**Subject: CB&I Responses to Request for Additional Information Regarding
Topical Report, CMS-720-03-PL-00020, Revision 0, Quality Assurance Program
Description**

ENCLOSURE 1
CB&I RESPONSE TO NUCLEAR REGULATORY COMMISSION (NRC)
REQUEST FOR ADDITIONAL INFORMATION (RAI)

Figure 1 – CB&I Nuclear Organization

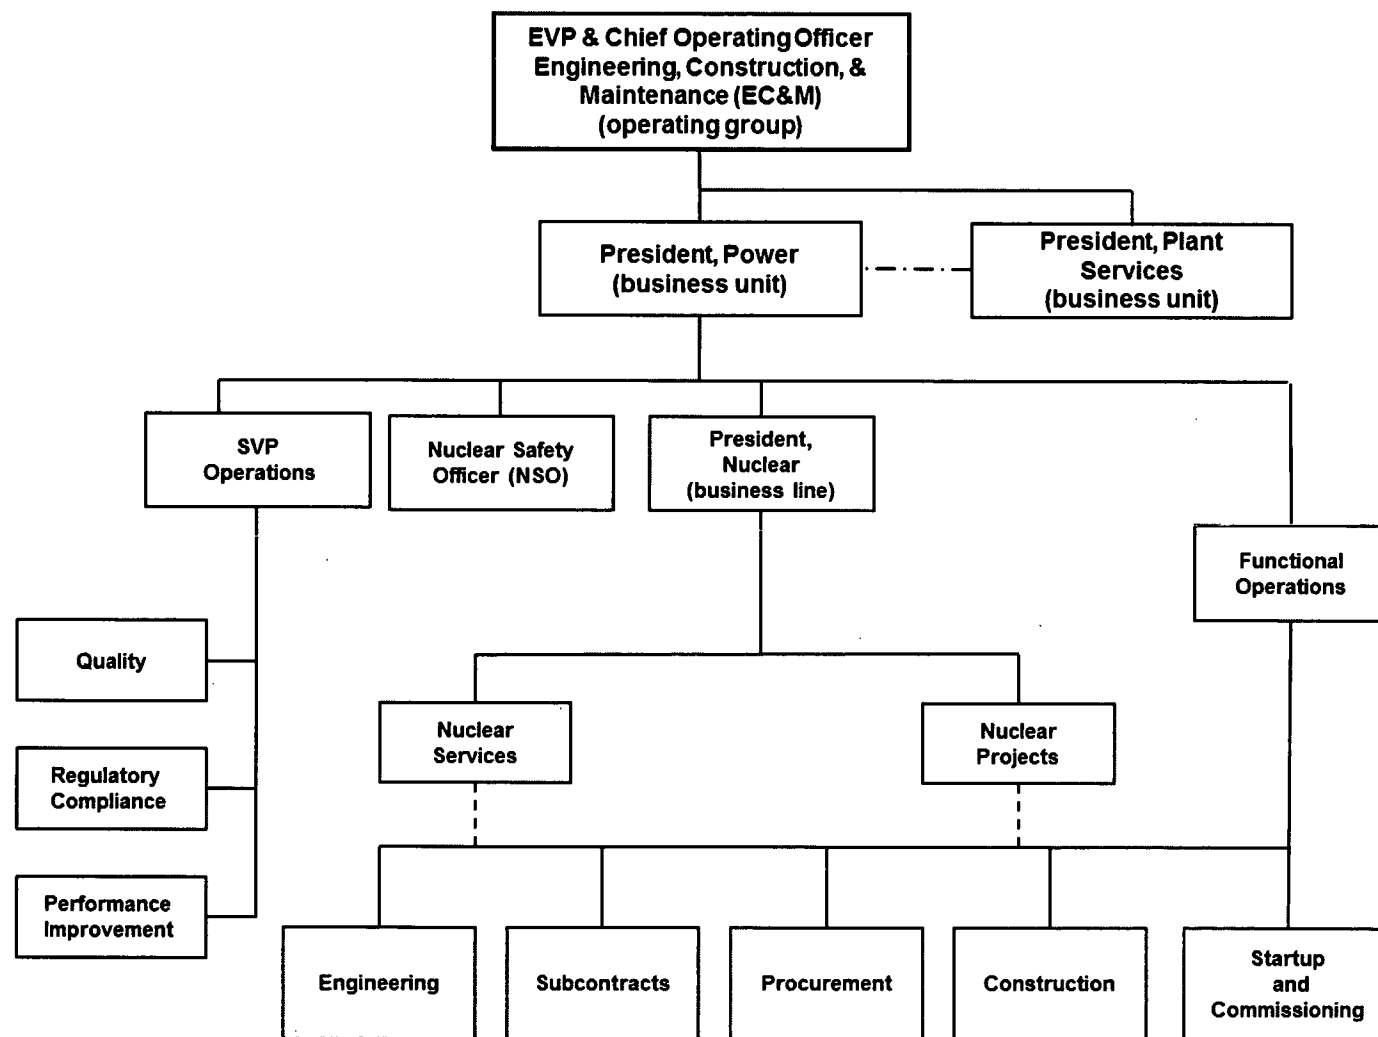
Reference to EH&S was deleted from the CB&I QAPD in Part II, Section 1.5, and Figure 1, Page 10.

- 2.0d In Figure 1, the CB&I organizational chart has a dashed line from SVP Functional Operations to both President, Plant Services and President, Nuclear (business line). Please provide a discussion for the interactions for these links.

The dashed lines in CB&I QAPD, Figure 1, Page 10, from the SVP (Senior Vice President) Functional Operations to the President, Plant Services and President, Nuclear were removed. A new dashed line was added between the President, Power and President, Plant Services to depict nuclear policy, as stated in Part II, Section 1.2.3, Page 5, "When the scope of work implements this document then the managing executive and plant service staff will fall under the nuclear policy direction of the President, Power." In Part II, Section 1.2.3, the statement, "(the dotted line on the CB&I Nuclear organizations chart shows that relationship)" was removed.
